Agenda Item 4
1062 Valley Road

1062 Valley Road

Continued consideration of a request for a recommendation in support of partial demolition, conversion of a garage to living space, the addition of a second story over the garage, various alterations around the residence, relocation of the driveway, and a new garage.

THE CITY OF LAKE FOREST BUILDING REVIEW BOARD -- BUILDING SCALE INFORMATION SHEET

PROPOSED SITE PLAN DIAGRAM

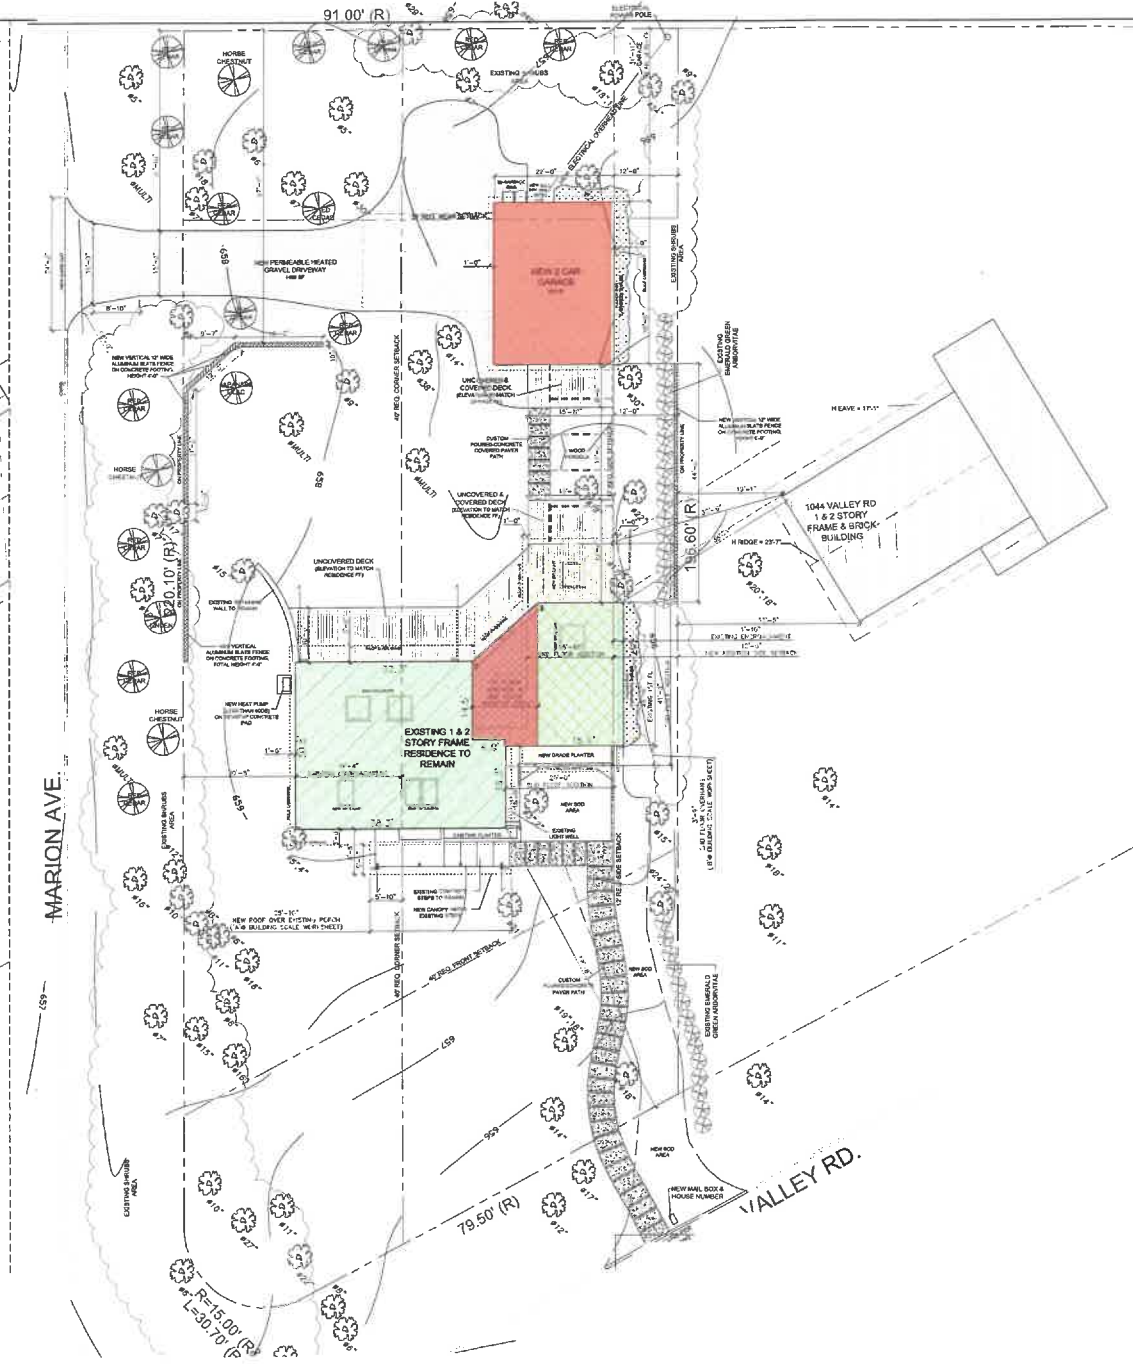
A significant change to the site plan is proposed. As proposed, the driveway will be relocated from Valley Road to Marion Avenue, near the southwest corner of the property. As noted above, a two car detached garage is proposed to the west of the house, near the north property line.

As noted above, the significant change to the site plan is the relocation of the driveway from Valley Road to Marion Avenue and construction of a detached garage. The area of the property where the driveway and garage are proposed has remained in a natural state for decades. The driveway is sited to minimize impacts on healthy trees of quality species. Realistically, construction in this area may have an impact on trees over time due to construction impacts, compaction of the soil, and changes in hydrology. The intent is that over the long term, the site will continue to have a wooded, natural character.

EXISTING LANDSCAPE ALTERATIONS

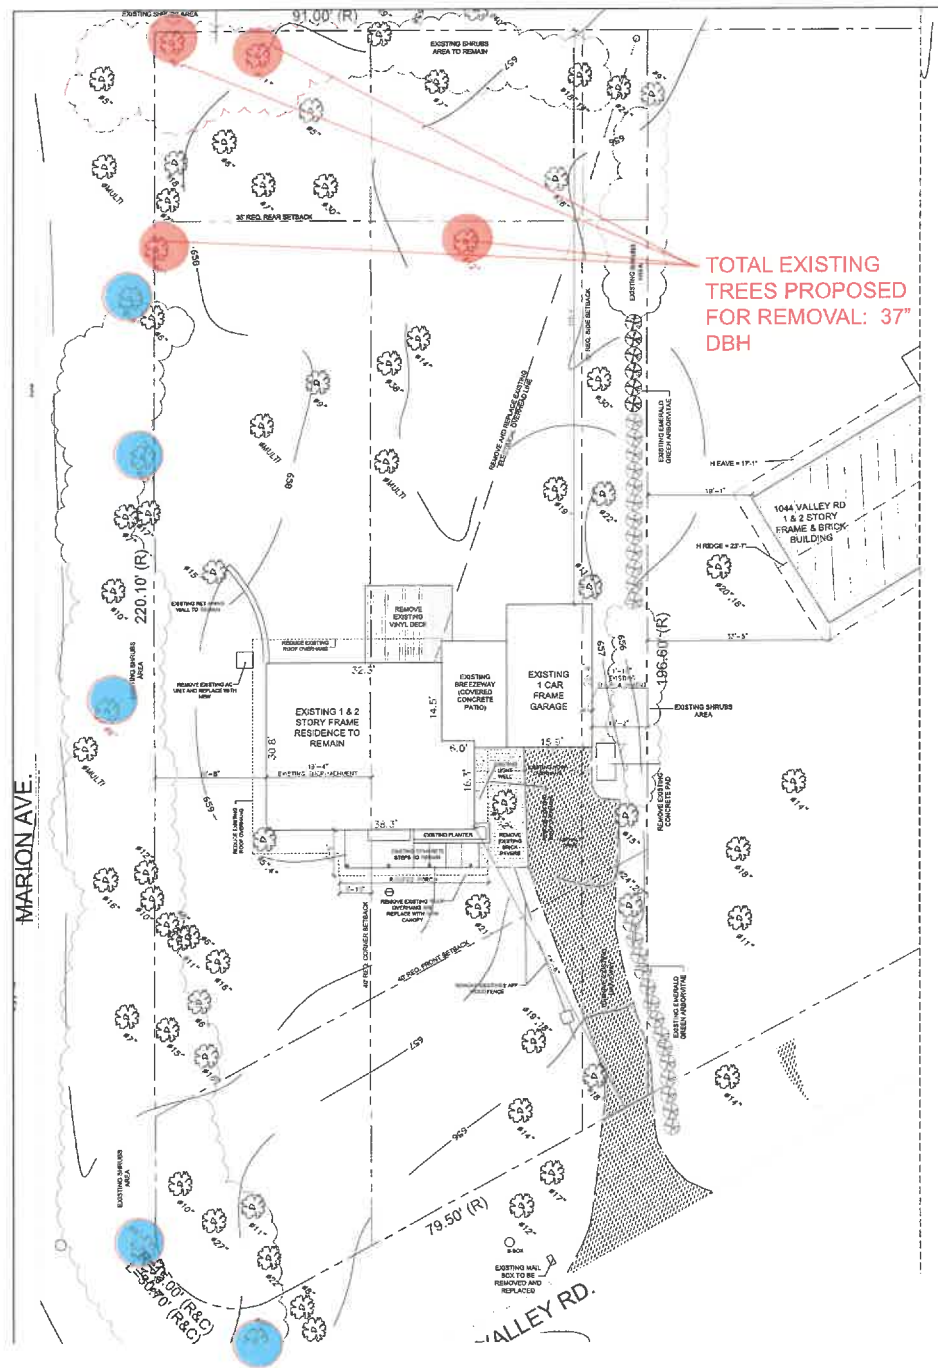
The petitioner's current tree removal plan indicates that four trees are proposed for removal, two Ash trees located in the southwest corner of the property and two trees that will be impacted by the driveway. As noted above, further due diligence will be done to evaluate the trees that will and may be impacted. Double inch for inch replacement is required for the trees that are in excellent condition, single inch for inch replacement is required for the trees in very good and good condition. The large lot affords the opportunity for replanting on the site.

- a. A detailed tree plan shall be submitted and will be subject to review and approval by the City's Certified Arborist. The plan shall identify all trees proposed for removal and trees identified for protection and preservation including parkway trees and trees on neighboring properties if there is a potential for off site construction impacts.
